WILLIAMSON COUNTY, TEXAS

CHANGE ORDER NUMBER: 1

Project:	<u>1811-278</u>
Roadway:	<u>Forest North-Anderson Mill</u>
CSJ Number:

3F: County Convenience. Additional work desired by the County. This Change Order adds drainage improvements on Tottenham Court at the County's request and provides the final balancing of unused items for the 8-inch water line relocation.

SHEET NO.
SF3 OF SF22

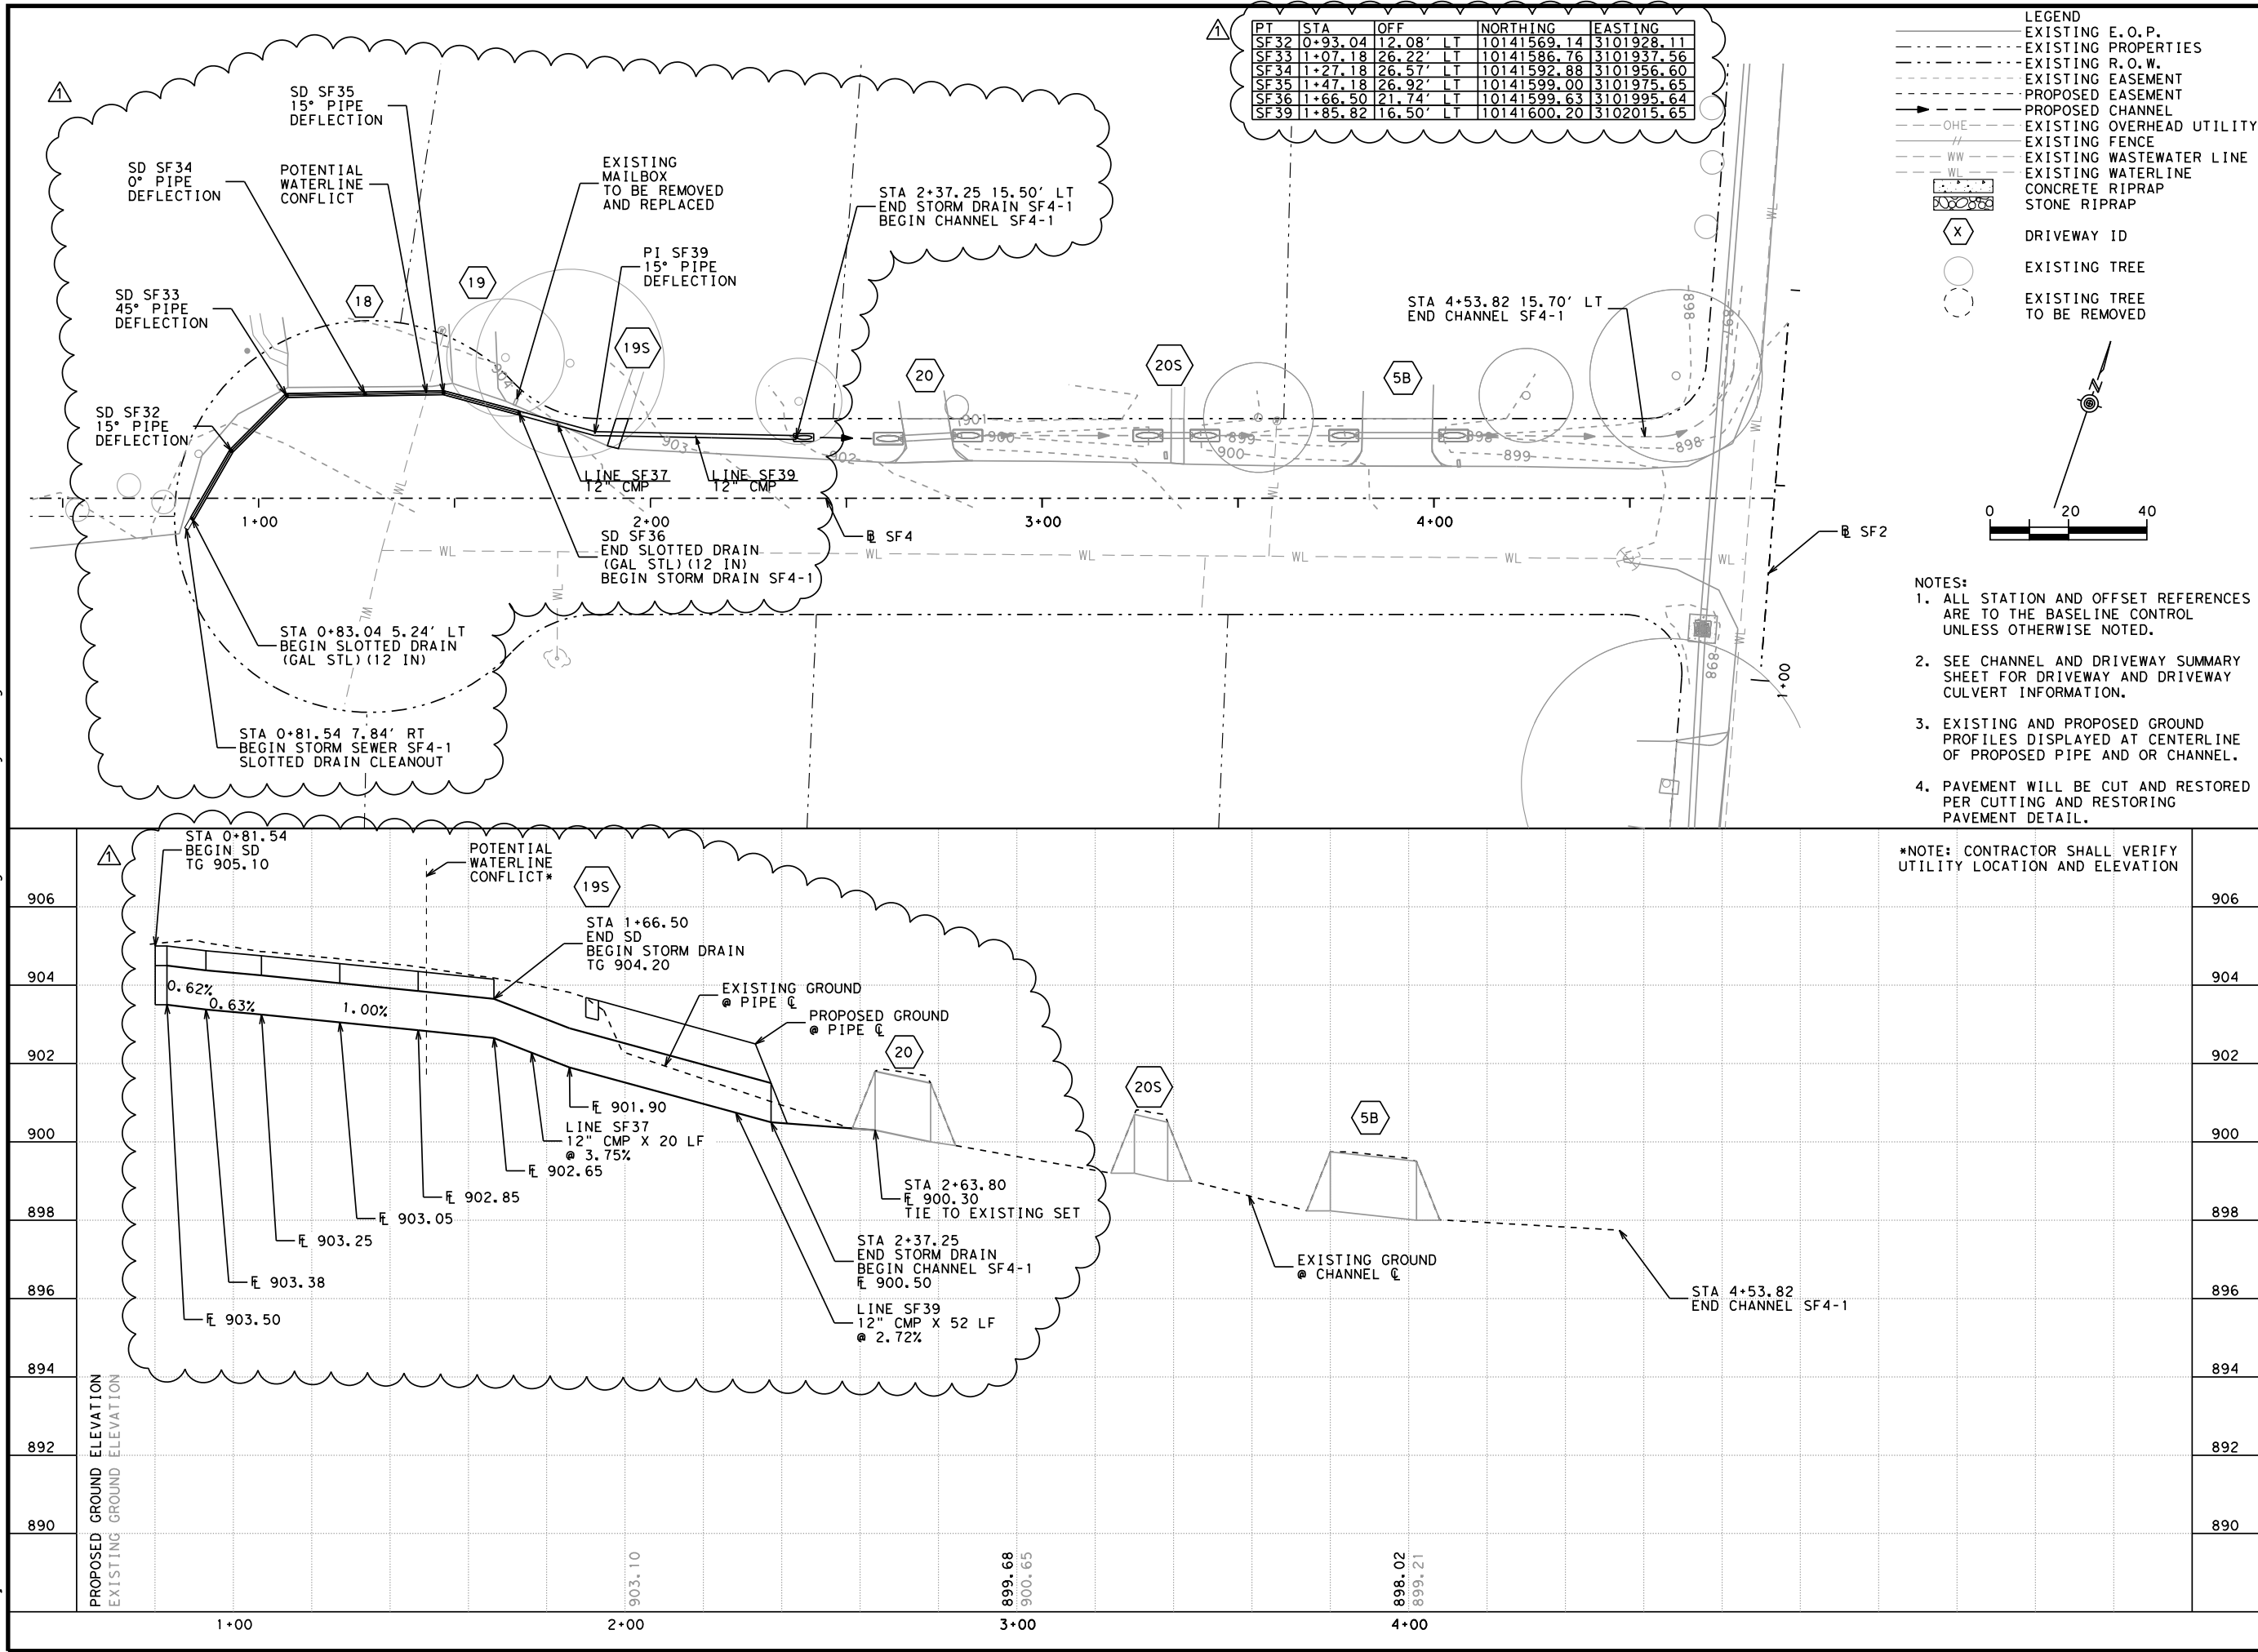
REV. NO.	BY	DATE	REVISION DESCRIPTION
1	CG	5/10/17	RFI 20 - REVISE CIP SF2
2	VO	6/6/19	ADD SLOTTED DRAIN TO SF4

SHEET NO. SF17 OF SF22

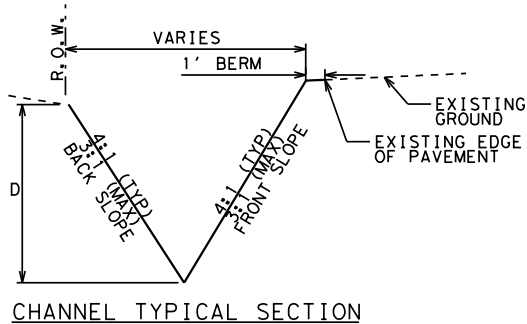
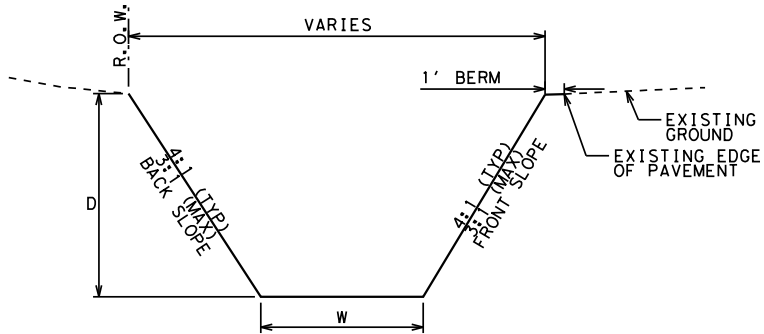
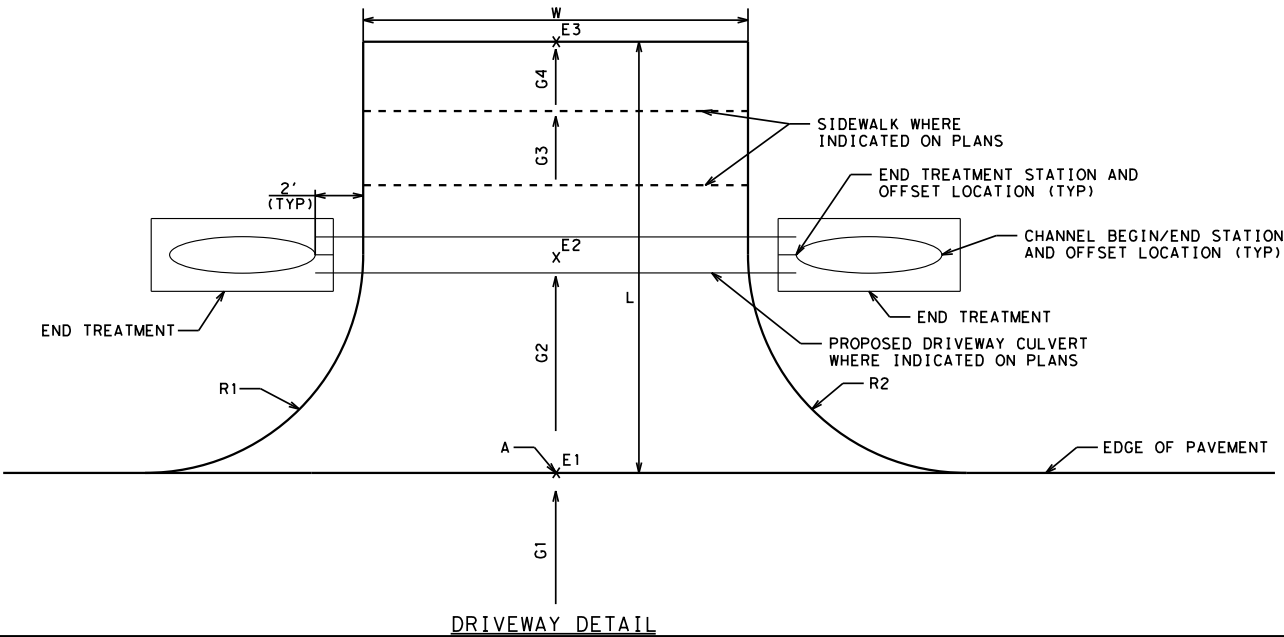
REV. NO. 1
REV. BY VO
DATE 6/6/19
REVISION DESCRIPTION
ADD SLOTTED DRAIN TO SF4

SF21 OF SF22

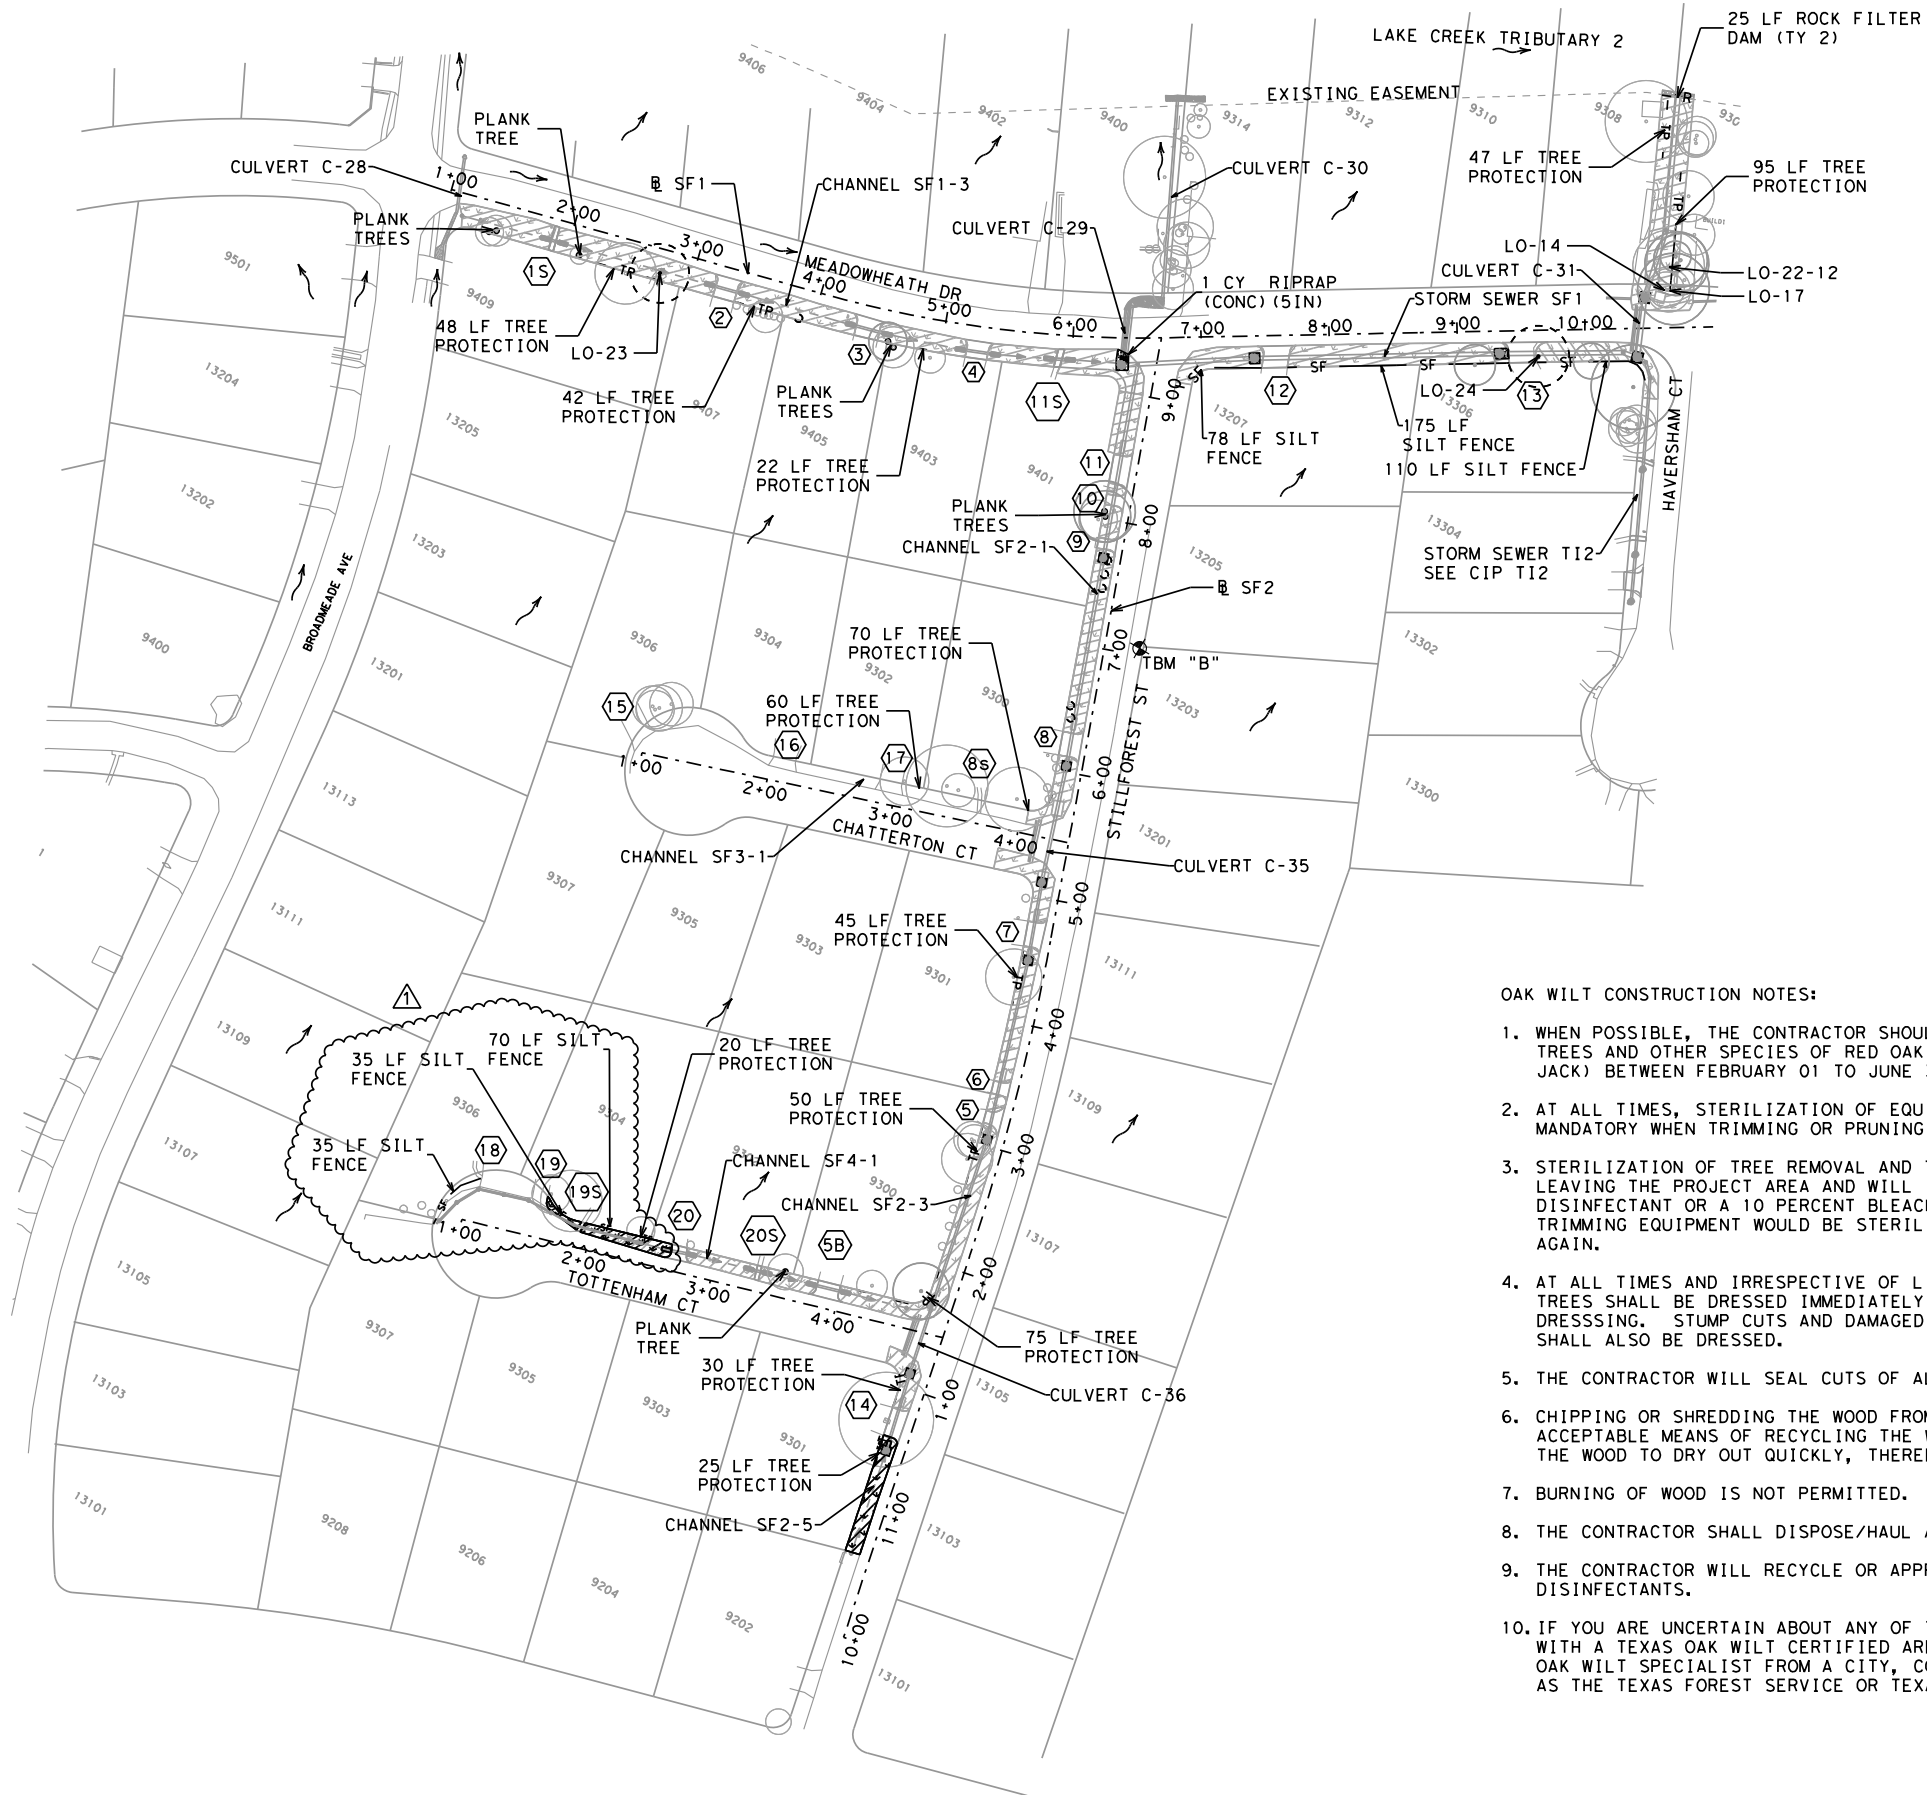
ADD SLOTTED DRAIN TO SF4

#1

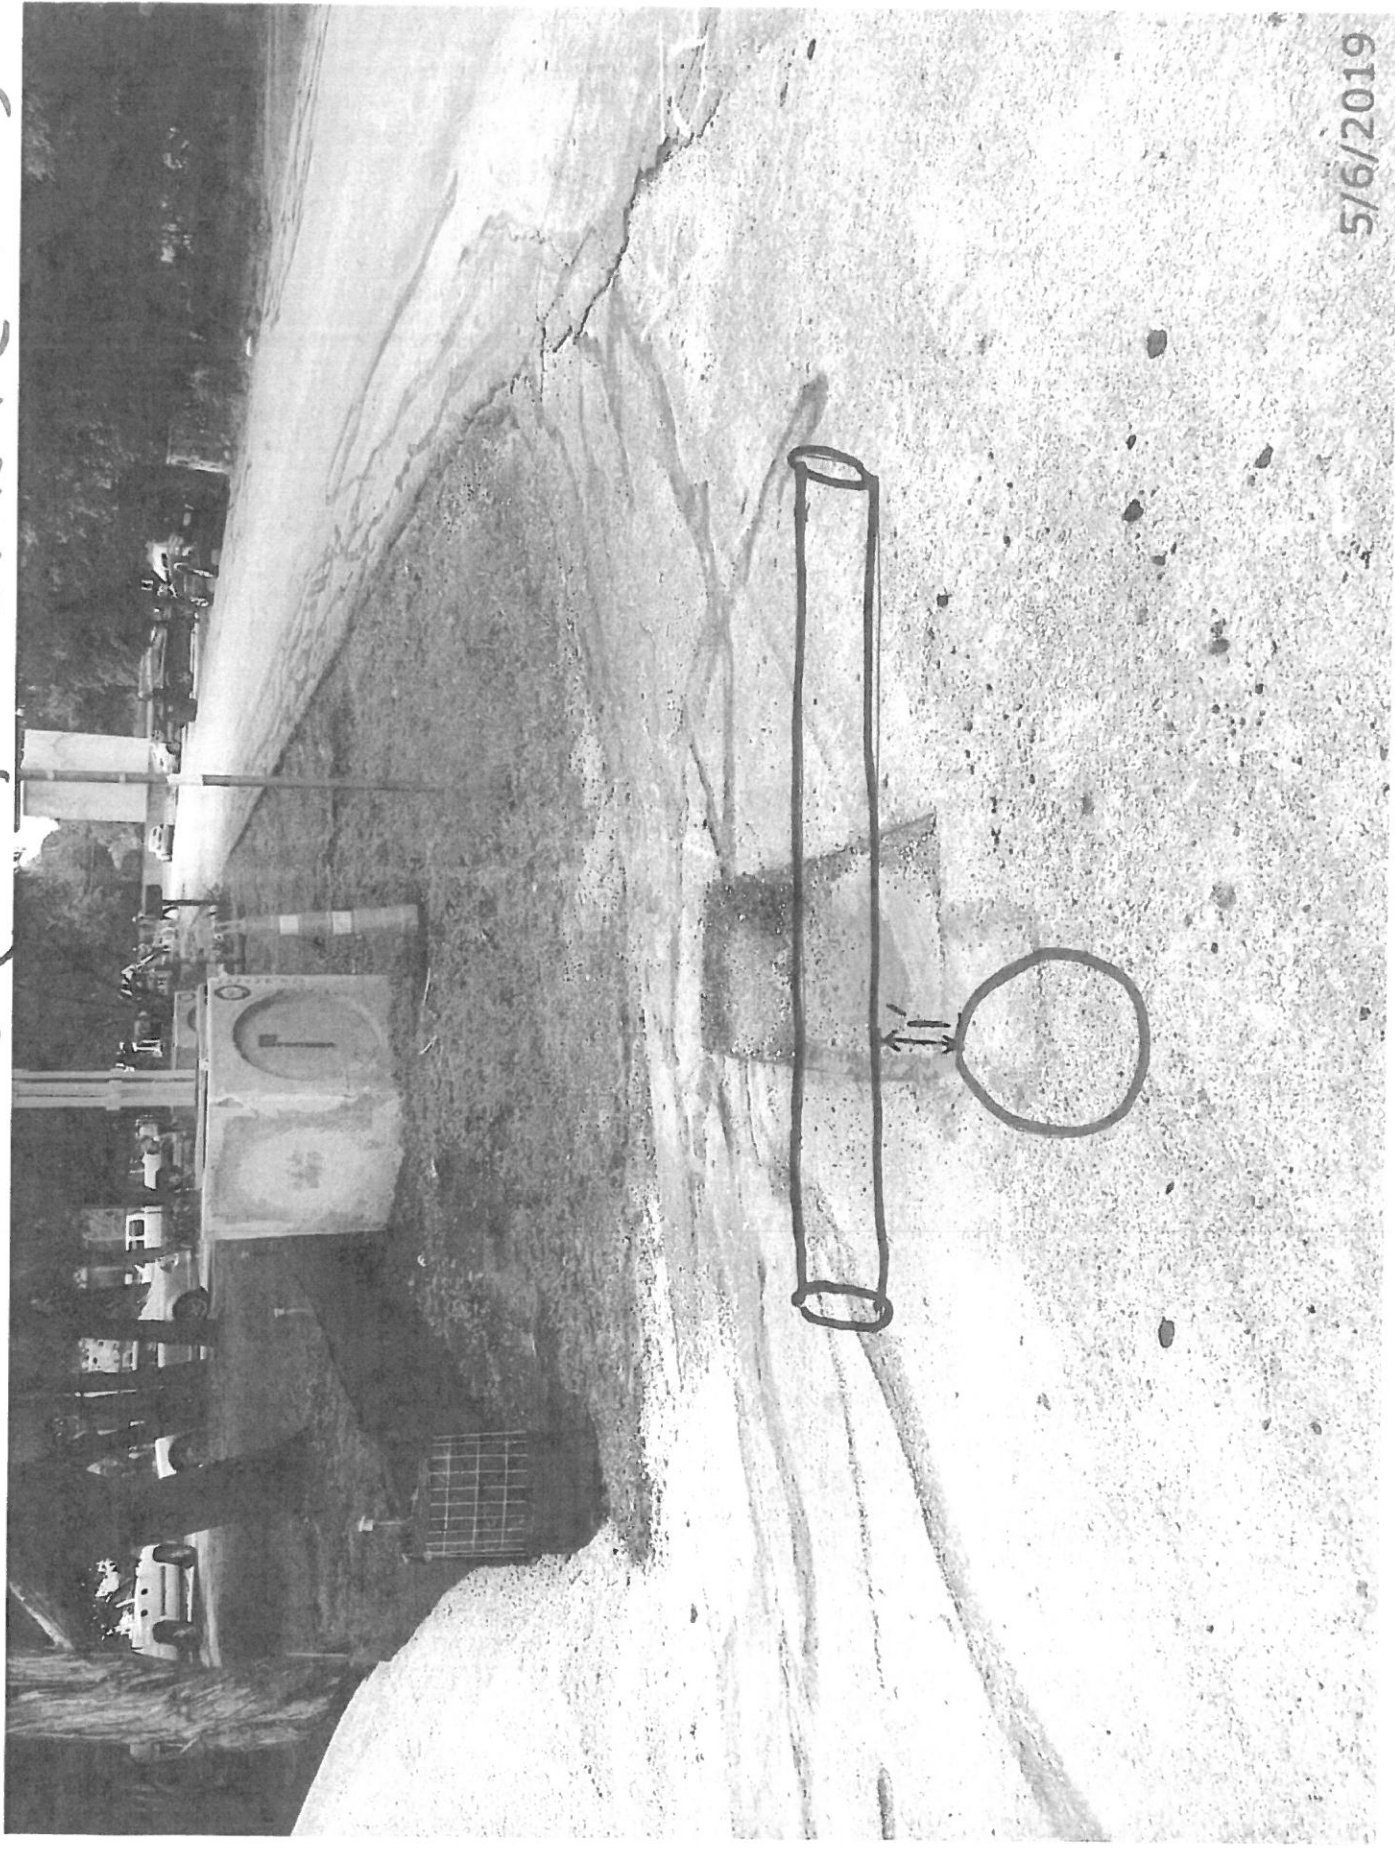
Can all proposed waterline relocation/installation be removed from the contract due to the current separation distances shown on the attachments? Photo #1 references Sheet C-103. Photo #2 references Sheet C-104. Photo #3 references Sheet C-102 at Station 1+42. Photo #4 references Sheet C-102 at Station 2+25.

On pothole 1, Sherbourne and Roxborough:

Bottom of existing waterline - 933.90
Top of proposed Storm- 932.90
Difference - 1'

AWU agrees that the lines are determined to not be in conflict and so can be removed from the scope of the project.
